**STAFF REPORT:** FEBRUARY 12, 2025 MEETING  
**APPLICATION NUMBER:** HDC2024-00594 (garage), HDC2024-00709 (doors)  
**ADDRESS:** 19410 WARRINGTON  
**HISTORIC DISTRICT:** SHERWOOD FOREST  
**APPLICANT:** DEJUAN MCCLENDON  
**PROPERTY OWNER:** DEJUAN MCCLENDON  
**DATE OF PROVISIONALLY COMPLETE APPLICATION:** JANUARY 21, 2025  
**DATE OF STAFF SITE VISIT:** JANUARY 24, 2025

**SCOPE:** EXPAND/ALTER GARAGE, REPLACE FRENCH DOORS

Right: Aerial views – 2016, 2020 and 2024. EagleView.

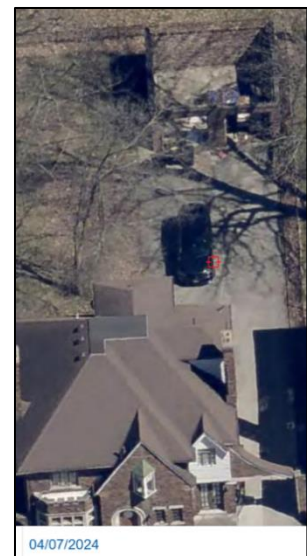
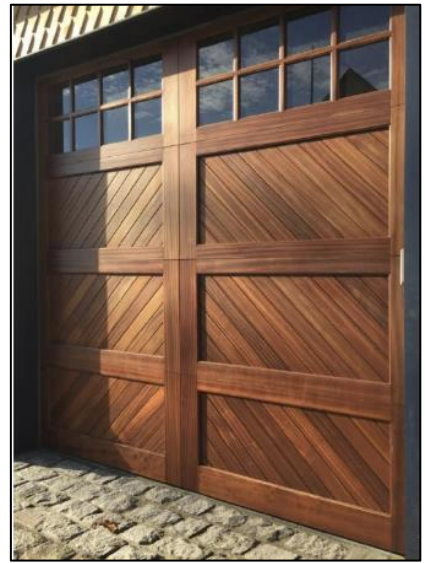
- The garage has brick veneer that matches the main house, but that is the only material and design component connecting the garage to the house. The (original) flat roof and lack of applied architectural details are a sharp contrast to the house’s steeply pitched and multiple gabled roof and highly ornamented facade.
- These aerial views show the garage roof was highly deteriorated by 2016; and a hole in one of the overhead doors is visible in the photo. By 2020 the roof had mostly collapsed. It was fully removed, along with the overhead doors, by 2024.

- Above is an interior image of one of the deteriorated overhead garage doors prior to its removal.
- It is staff's opinion that the removal of the paneled doors and flat roof did not alter the features and spaces that characterize the property.

- While the garage has lost some of its integrity, the retention of the masonry-clad walls and individual garage door openings are distinctive features that allow the structure to remain relatable to the house and property.

*Applicant rendering*

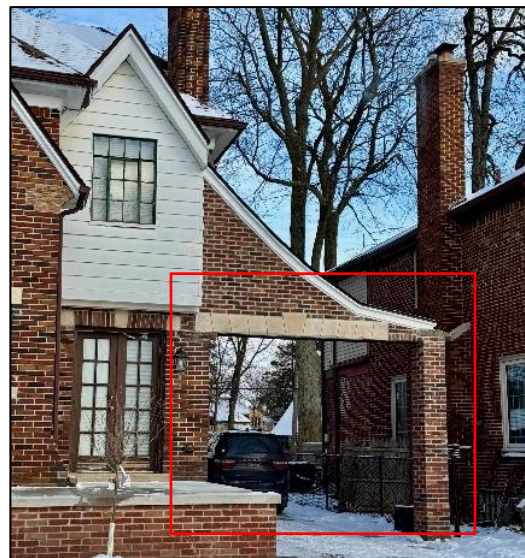
- The Sherwood Forest Elements of Design, which should be referenced when reviewing additions and new construction, do not call out features of historic garages within any of the elements. Therefore, staff reviewed the proposal in direct relation to the property and house. The pitch and design of the new roof and porch area emulate the roof pitch/extension that connects the house with the driveway; staff believes this new construction is compatible with the property.

- It is staff's opinion the smooth-faced clapboard siding is the most architecturally appropriate and compatible material for the garage and its visual connection to the dwelling.

- Smooth-faced clapboard siding is used on the garage's gable walls.
- The garage doors will be painted; the color will be submitted for review by HDC staff.
- The front door will be the stained wood door with arched leaded glass opening. Should another door be considered by the applicant, it will be submitted to staff for review.

*Right: Applicant photo of a proposed design for a front door. It is staff's opinion this door is compatible with the house.*

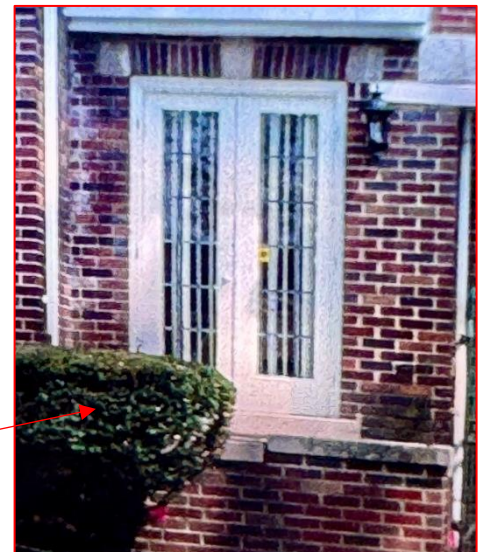
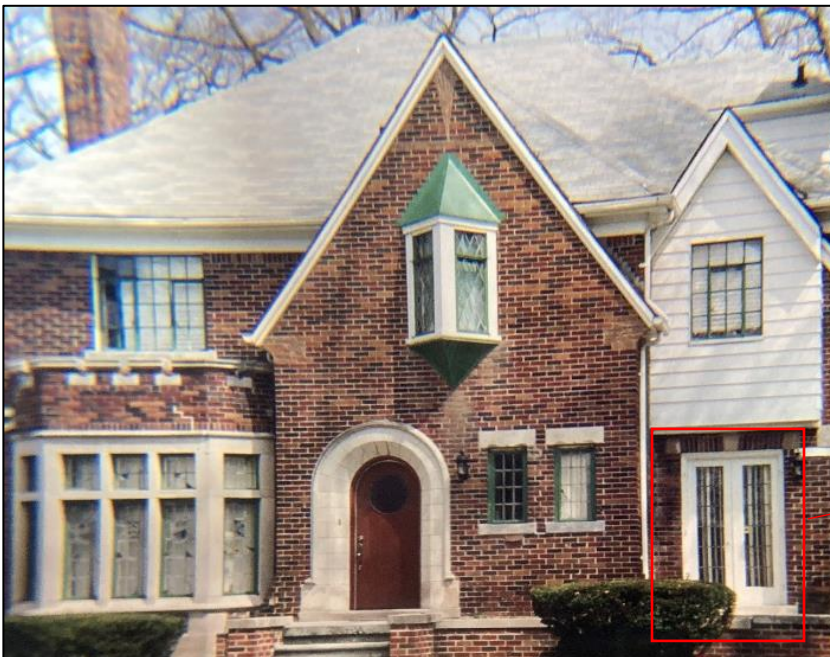
- It is staff's opinion that the existing entry door might not be the original historic door due to its texture and visual appearance:
  - Clear glass in the round opening (staff does not know if it ever contained decorative glass, this glass was in place at the time of designation).
  - No evidence of a mail slot, a common feature on many early 20<sup>th</sup>-century front doors.
  - The materiality and finish of the wood door and lock and handle appear to mimic historic components, but don't match the patina of aged early 20<sup>th</sup>-century doors and hardware.
- Staff reviewed the selected replacement doors submitted by the applicant. Staff believes the one included on this page (door only – not the wood trim/surround) is a compatible option, as it is consistent with the general characteristics of this house and its period of construction.
